LONDON BOROUGH OF ENFIELD

PLANNING COMMITTEE

Ref: 15/01513/FUL

LOCATION: 46 And 48 Lancaster Avenue, Barnet, EN4 0ET,

PROPOSED BASEMENT PLAN

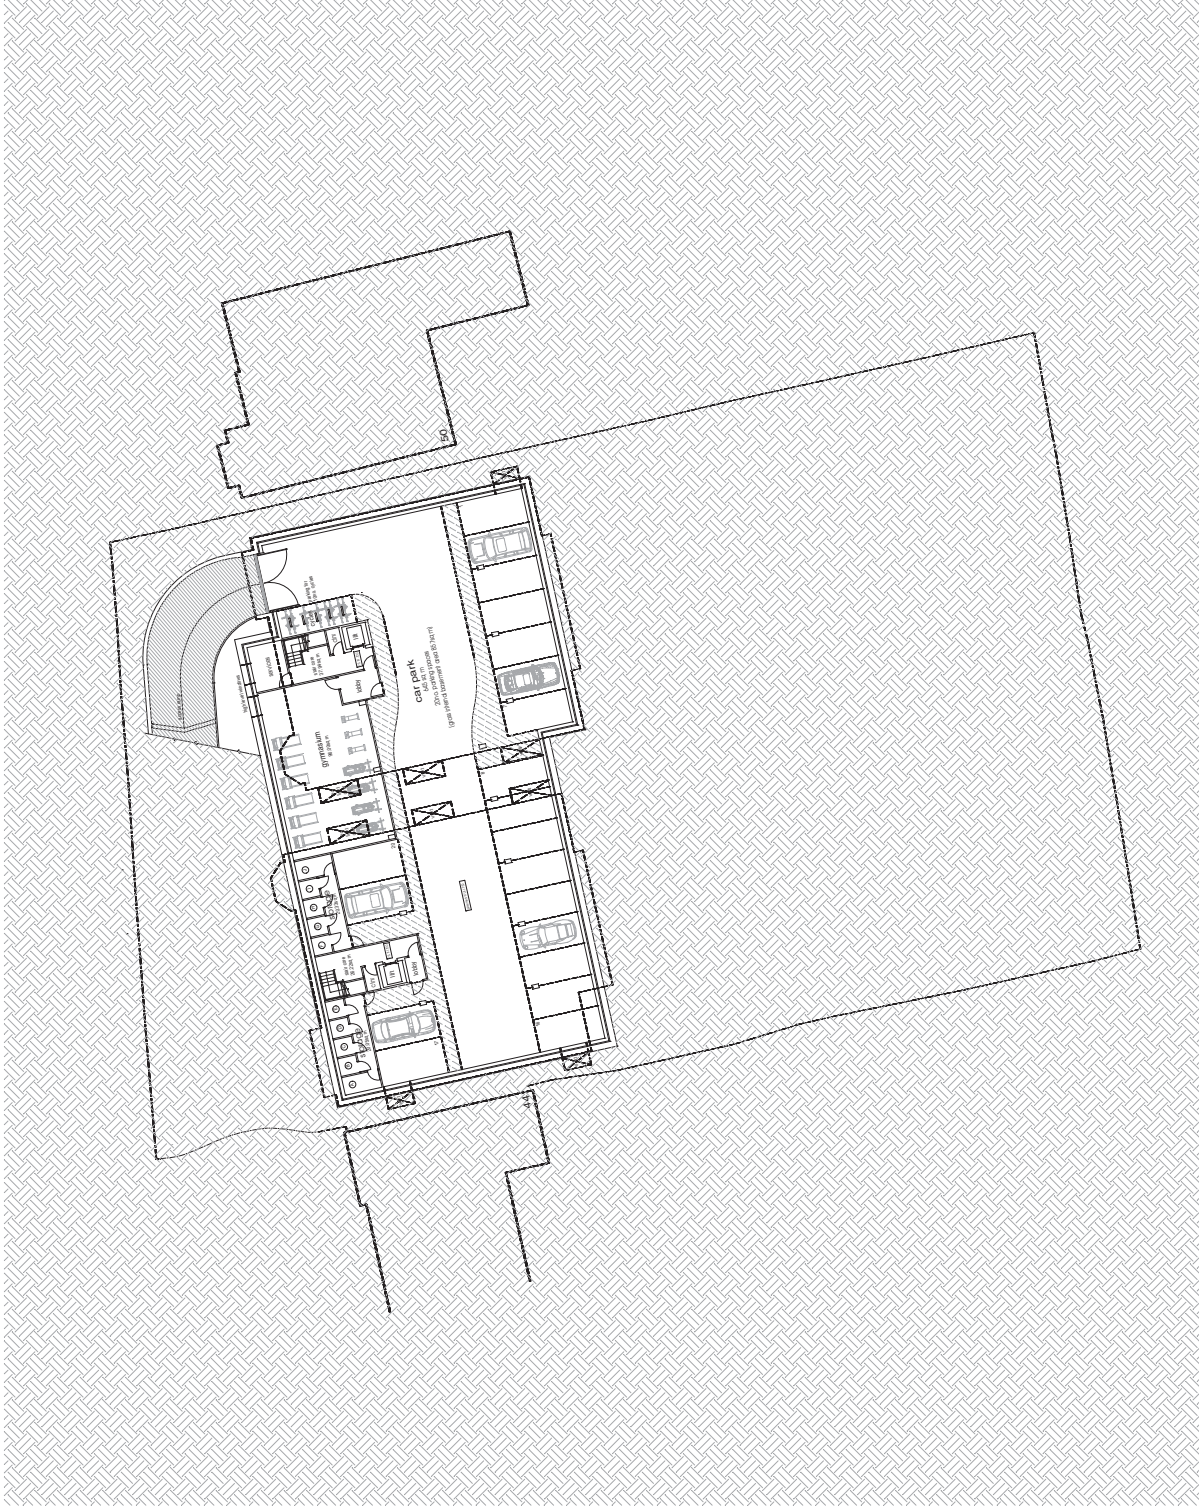
- 2.13 The basement would provide for 20 car parking spaces, 10 cycle parking spaces, 10 external storage units and a gymnasium.

- 6.5.4 The proposed development would exceed the maximum parking standards and provide 20 spaces within the basement with a ratio of 2 spaces per 2 and 3-bed unit. The Traffic Officer has raised concern regarding an oversupply of parking, however a variation is considered acceptable in this instance having regard to:

BLOCK A

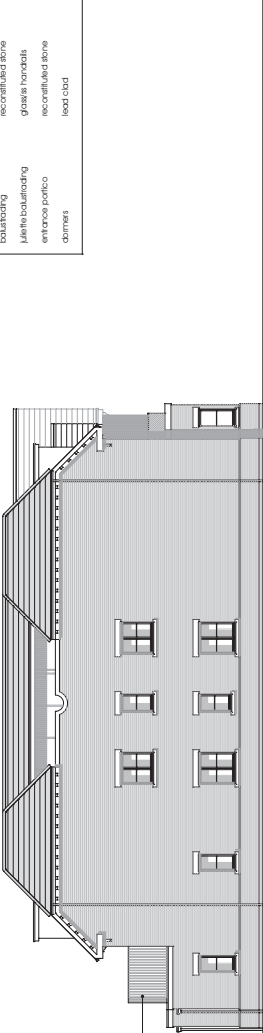
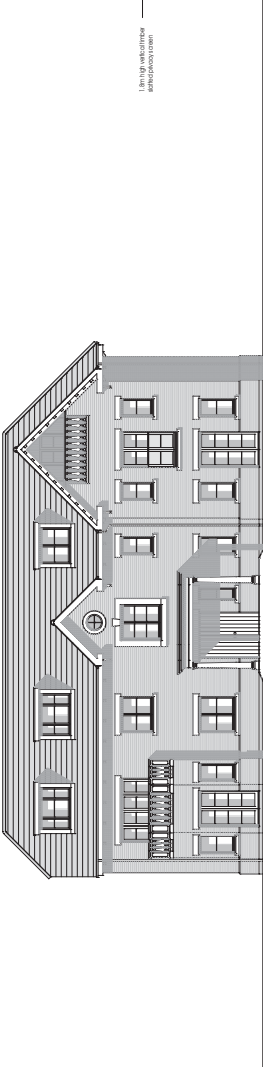
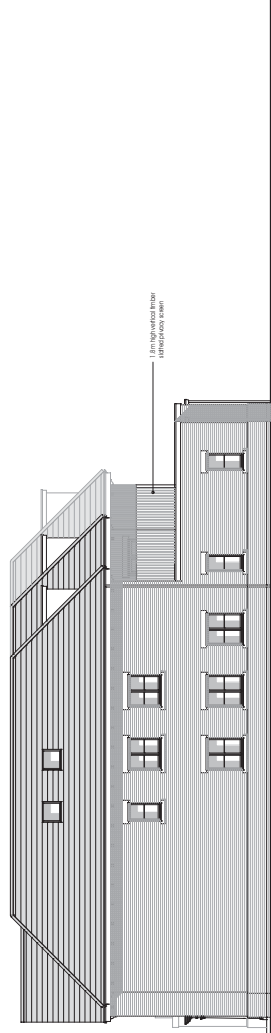
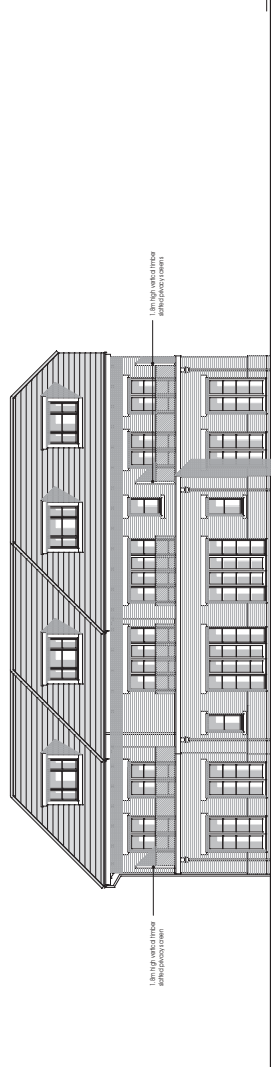
- 6.2.12 It is noted that the architectural design of the proposed development takes some cues from the adjoining houses, and the Design and Access Statement cites 'georgian influences'. However on balance, it is considered that the design is unacceptable and would introduce a number of features alien to the street scene. For example:

- The pitched roofs with large crowns which would provide for the 3-bed units. The amount of accommodation within the roofs would be inconsistent with other buildings in the local area and would result in complicated and unbalanced pitched roofs with large crowns that would add to the overall bulk and mass of the buildings.

- The roof terraces to the 3-bed units which would be visible between the buildings.
 - The terraces and balconies on the front facades, by reason of their number, position, size and design, would be incongruous features that would detract from the character and appearance of the buildings.

- The irregular fenestration on the front facades with different shapes, sizes, decorative balustrades and juliet balustrades.
 - The 5m and 4.4m (d) x 1.8m (h) timber slatted privacy screens to the first floor rear terraces that would increase the overall bulk and mass of the buildings as viewed from the adjoining properties.

- The entrance canopies with flat roofs and smooth columns which appear to be an afterthought and do not sit comfortably within the architectural design of the buildings unlike other entrance canopies within the local area.
- The number of different materials ie. red brickwork, slate roofs, lead dormers, metal railings, glass balustrades, stone balustrades, timber privacy screens, upvc framed fenestration, timber framed rooflights, stone cills and heads.
- The basement car park, which whilst not unacceptable, would be relatively new to the street scene.
- The concierge building / refuse store which in itself would be alien to the street scene and would reduce the openness of the forecourt.

proposed lancaster avenue elevation

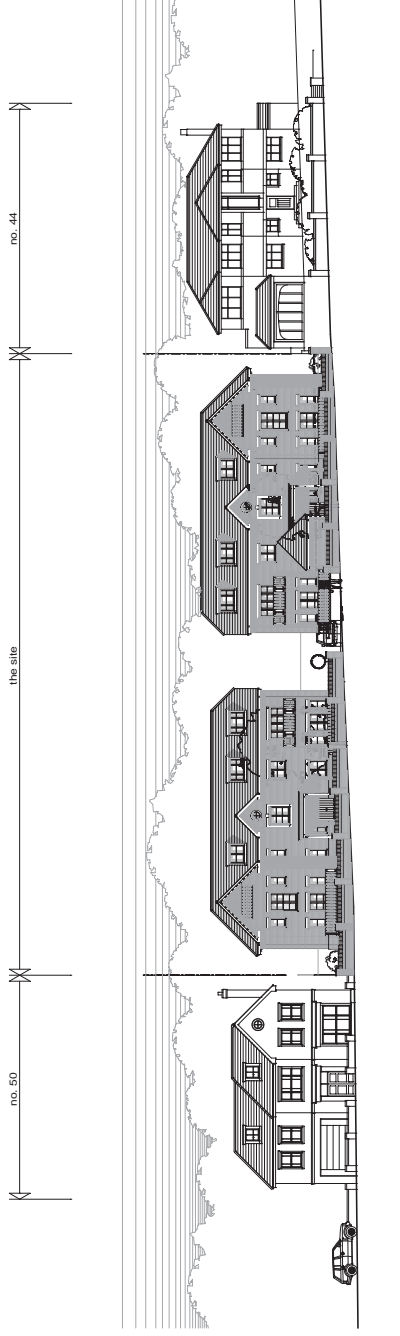
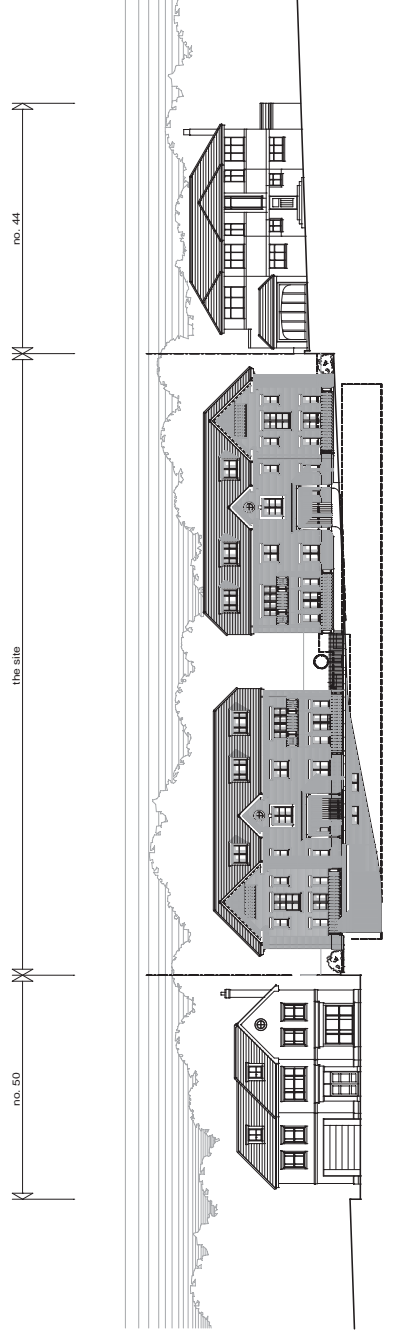
- 6.2.11 The proposed development would maintain the appearance of two plots and the rhythm of the street scene by providing 2x detached buildings. The buildings would provide an appropriate graduation in height between the adjoining houses following the natural slope of the land. However, the bulk and mass of the buildings would be inconsistent with the scale of other buildings in the local area. This is evidenced by a relative comparison of the building footprints, the floor areas at each level, the horizontal character, and the pitched roofs with large crowns. The bulk and mass of the buildings would dominate the adjoining houses and have an overbearing impact on the street scene. The visual impact would be emphasised by their position on the high side of the street.

6.2.15 Lancaster Avenue is predominantly characterised by open forecourts some of which have low height retaining walls and boundary walls. The proposed development would provide a new boundary wall with railings 1.4m (h). The front boundary treatment by reason of its height and design would be inconsistent with the street scene and detract from the open, leafy character.

- Insufficient information to assess the changes in levels and the design of the forecourt. For example, the site plan suggests that pedestrian access to the front entrances would be ramped ie. no steps are shown on the plan. However, this does not appear to be possible having regard to natural ground level and the sections (dwg no. 5104_P_101 and 5104_P_130).
